# TECHNICAL MEMORANDUM

## Utah Coal Regulatory Program

RE: Lower Robinson Creek Diversion Channel Repair, Alton Coal Development LLC, Coal Hollow, C/025/0005

Excerpt from Drawing 5-20

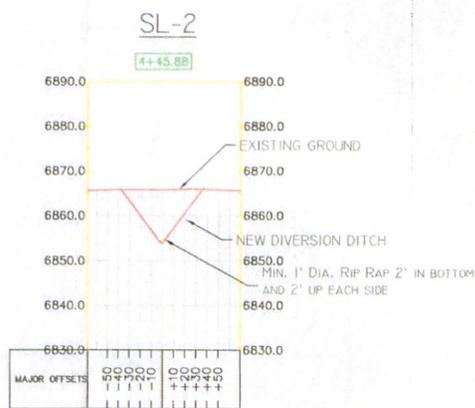
A review of the Coal Hollow MRP was conducted concerning the Lower Robinson Creek Diversion. Section 742.320 Diversion of Perennial and Intermittent Streams of Chapter 7 references Appendix 5-3 and Drawings 5-20 and 5-21. Appendix 5-3 designs for a 10-year 6-hour event and prescribes the use of heavy riprap  $D_{50}=1.0$  ft in the upper half of the diversion and  $D_{50}=0.5$  ft riprap in the lower half of the diversion. Drawing 5-20 is a plan view of the diversion and Drawing 5-21 is a profile view with cross sections of the elbows of the diversion as SL-1, SL-3, and SL-5 and cross sections of the channel as SL-2 and SL-4.

Cross Section SL-2 from Drawing 5-21

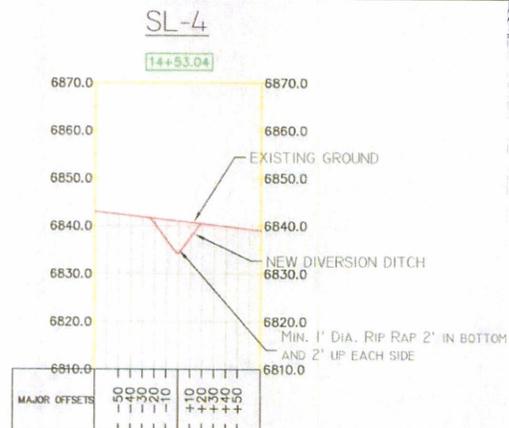
Cross Sections SL-2 and SL-4 specify for "Min. 1' Dia. Rip Rap 2' in bottom and 2' up each side." On April 19, 2012 at 8:30 am Kirk Nicholes of Alton Coal was informed that installation of rip rap must meet this standard.
